**CITY OF EL PASO, TEXAS
AGENDA ITEM
DEPARTMENT HEAD'S SUMMARY FORM**

That the City Council approves a change order in the amount of \$264,139.21 to J.A.R. Concrete Inc. for the increase in landscaping, irrigation and other elements to the project under Contract No. 2019-452 Paso Del Norte (PDN) Port of Entry (POE) Roundabout Improvements. This notice provides for the additional scope of work, which allows for additional capacity to the awarded contract. The new contract sum, including this change order notice and previous change order notices is \$2,662,492.51. The City Manager, or designee, is authorized to execute any documents and contract amendments needed to carry out the intent of this resolution.

CITY OF EL PASO CONSTRUCTION CHANGE ORDER

CONSTRUCTION CHANGE ORDER NO.: <u>3</u>		DATE: <u>July 30, 2020</u>		<input type="checkbox"/> SCOPE CHANGE
PROJECT: <u>Paso Del Norte (PDN) Port of Entry (POE) Roundabout Improvements</u>		SOLICITATION NO.: _____		<input checked="" type="checkbox"/> CONSTRUCTION CHANGE
		CSJ: 0924-06-530 Solicitation: 2019-452		
Original Contract Amount: \$ <u>2,394,924.50</u>			Contract Time to Substantial Completion: <u>218</u>	
Net Change by previous

AC 112" X 18" FIBERSTONE LOW BOWL PLANTER NOT TO SCALE

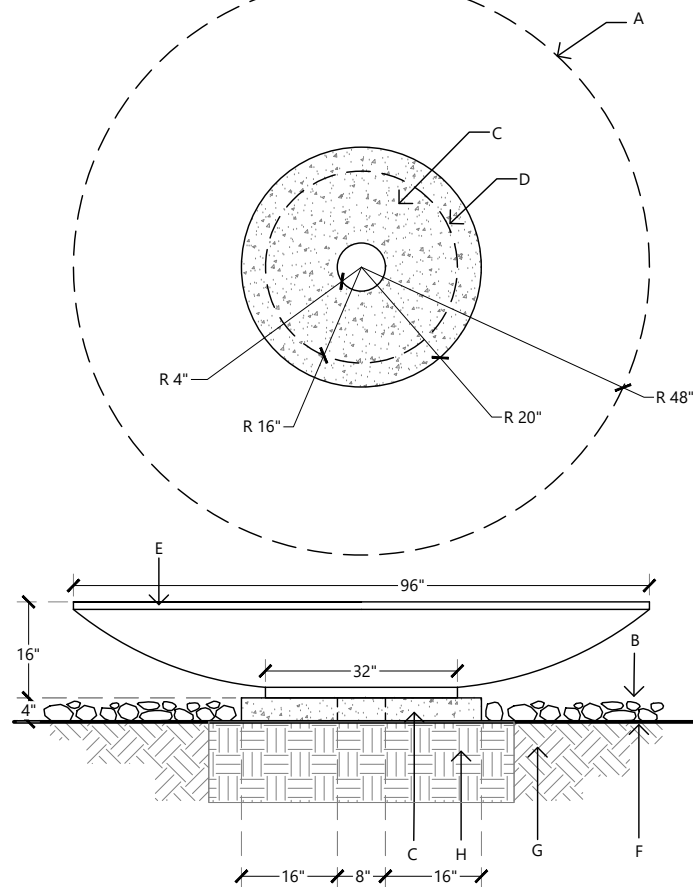
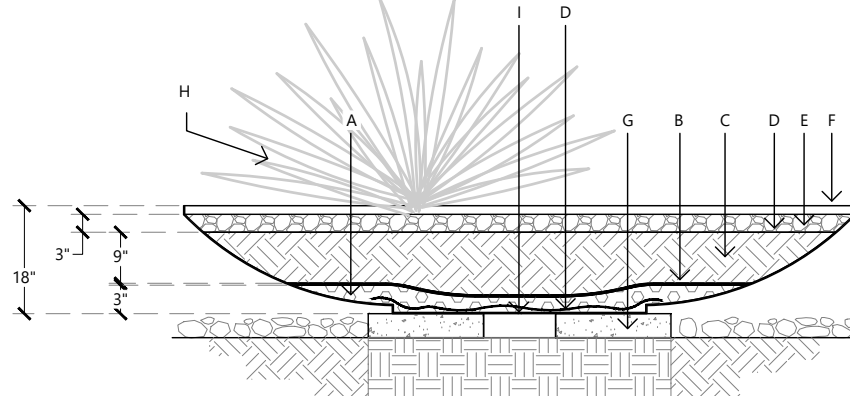
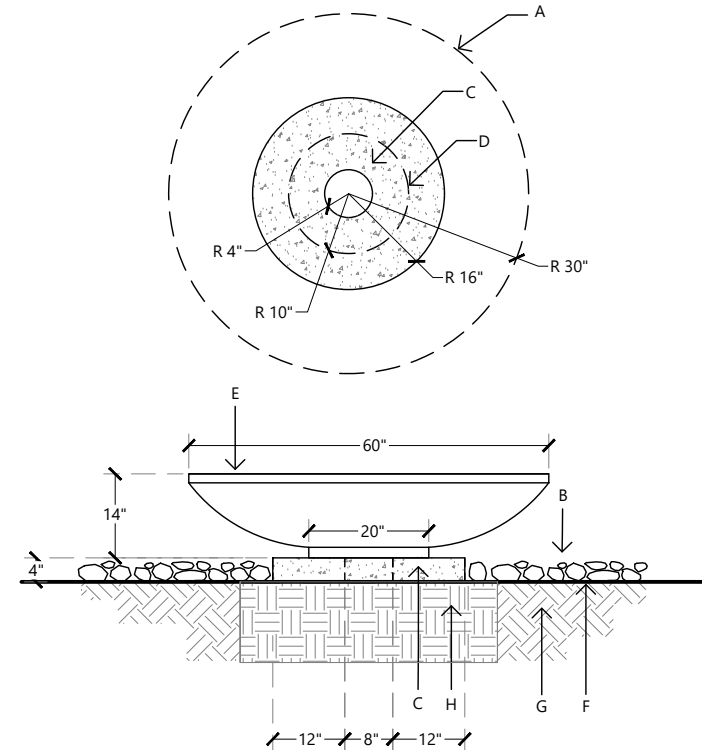
- **Drawings:** Revised sheets Structural Sheets S,0 – S,5, Landscape General Notes LG-001 – LG-002, Landscape Plan Sheets LP101 – LP104, Irrigation Schedules LI-101 – LI-103, Construction Details LC-501 – LC-510, Landscape Details Sheets LP-501, Irrigation Details LI-501.

- Add new item 193-6010 PLANT REPLACEMENT (30-GAL) with an estimated quantity of 12 EA with a unit price of \$424.00/EA.
 - Add new item 1002-6002 112"X18" PLANTER with an estimated quantity of 7 EA with a unit price of \$7,416.03/EA.

- Add new item 1002-6003 96"x16" PLANTER with an estimated quantity of 18 EA with a unit price of \$3,813.88/EA.
 - Add new item 1002-6004 60"x14" PLANTER with an estimated quantity of 10 EA with a unit price of \$2,053.75/EA.

For planters, I found a vendor selling the same planters as proposed on the plans. Cost and shipping were taken for the planters and 15% was added for overhead and profit for the installation. When talking to the contractor about this item, they mentioned they are including careful handling into the cost as these planters are large, heavy and fragile and they are at risk of damaging the planters while they are under their care. The cost the contractor provided was reasonable compared to our estimate. ✓
